RSN: 1881854 | PERMIT#: 25-2513934-CM

City of Aurora Building Division
Reviewed for Code Compliance
Approved as Noted: Robert Lowman
Date: May 06, 2025
2021 INTERNATIONAL CODES & 2023 NEC

1 LEVEL 1 GROUNDING PLAN - F
SCALE: 1/8" = 1'-0"

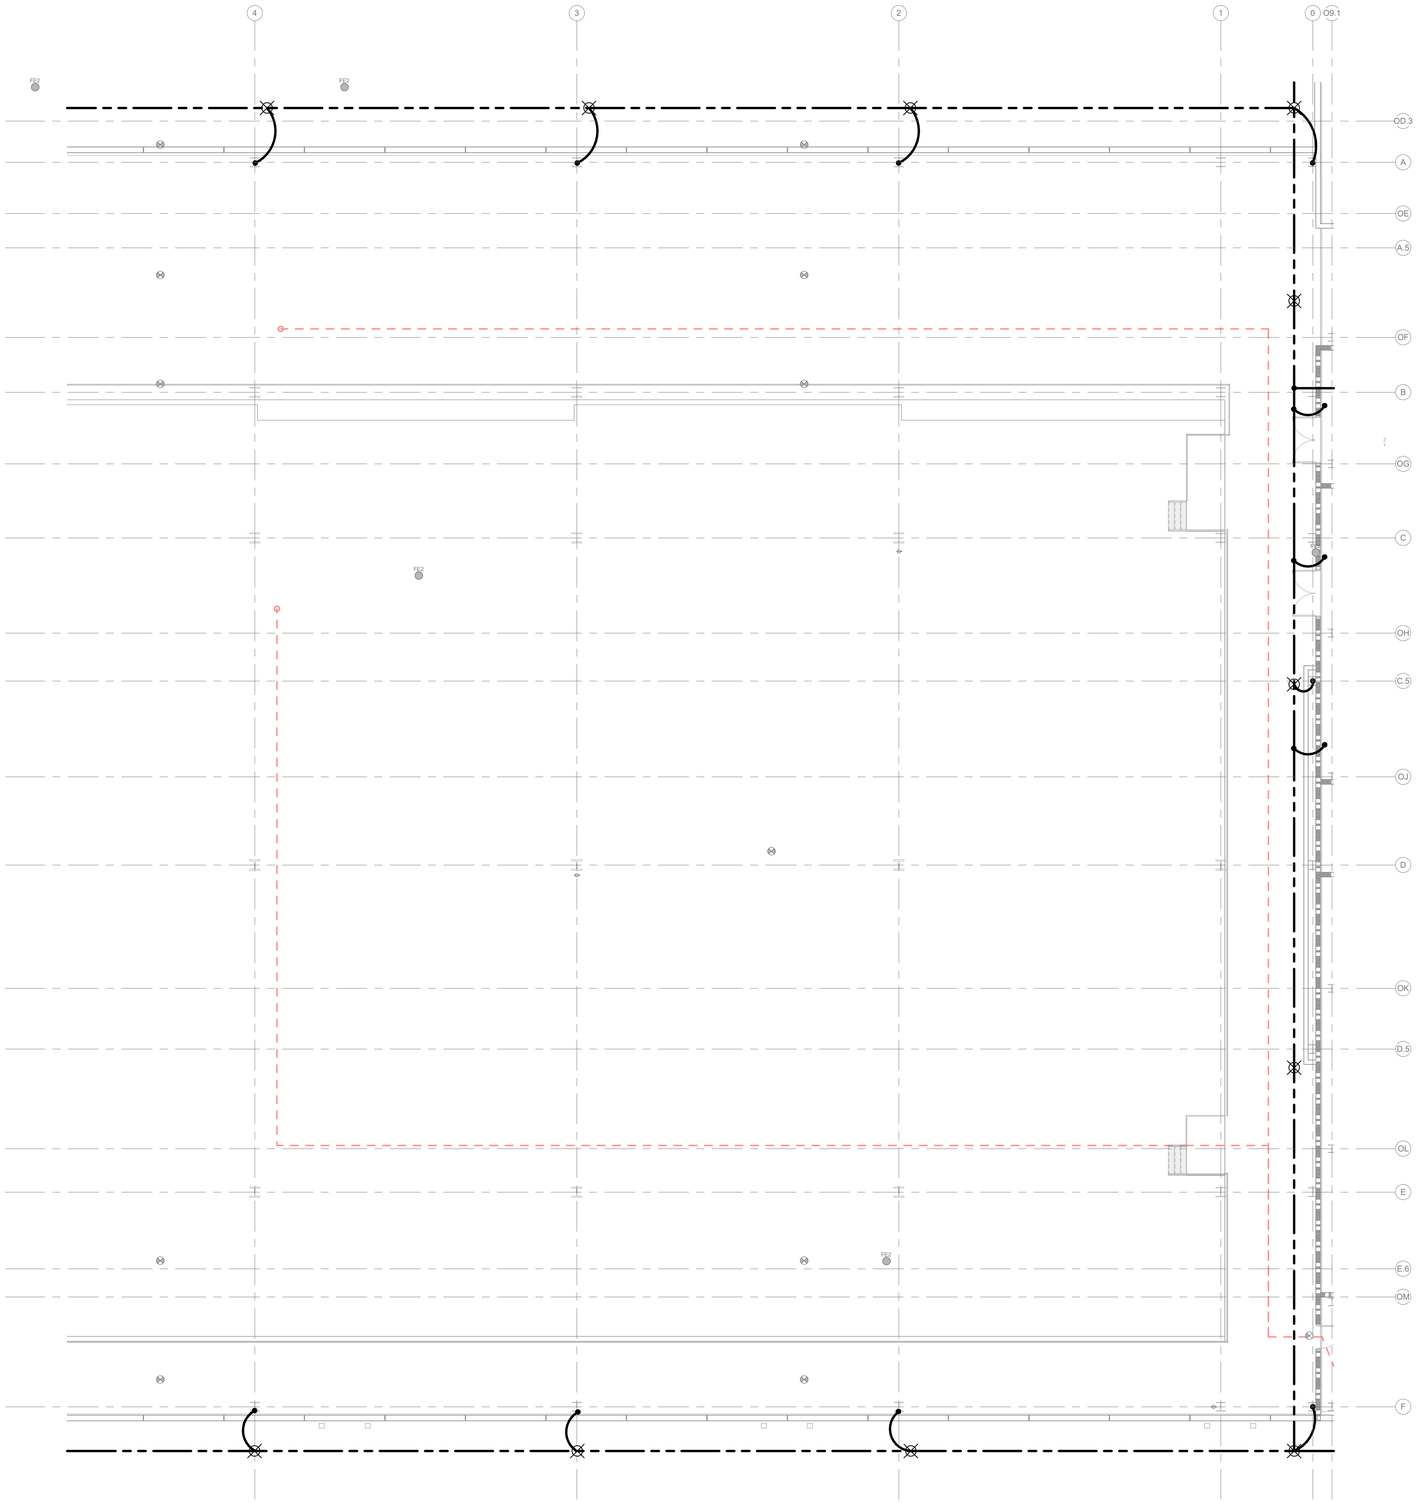
A. ~~SEE DRAWING E0.01 FOR LEGENDS, NOTES AND ABBREVIATIONS.~~
B. SEE DRAWING E05 SERIES FOR GROUNDING DETAILS AND DRAWING E03-24 FOR GROUNDING RISER DIAGRAM.
C. REFER TO SPECIFICATION 25 05 26 FOR ADDITIONAL GROUNDING REQUIREMENTS.
D. COORDINATE CLOSELY WITH LOCAL AUTHORITY HAVING JURISDICTION AND APPROPRIATE CONTRACTOR(S) TO CONFIRM ALL FINAL INTERCONNECTION LOCATIONS AND REQUIREMENTS.
E. WHERE EQUIPMENT IS CALLED OUT AS HAVING TWO GROUND CONNECTIONS, EACH PIGTAIL SHALL CONNECT BACK TO A SEPARATE GROUND GRID LATERAL.
F. ALL UNDERGROUND CONNECTIONS SHALL BE EXOTHERMIC CONNECTION TYPE.
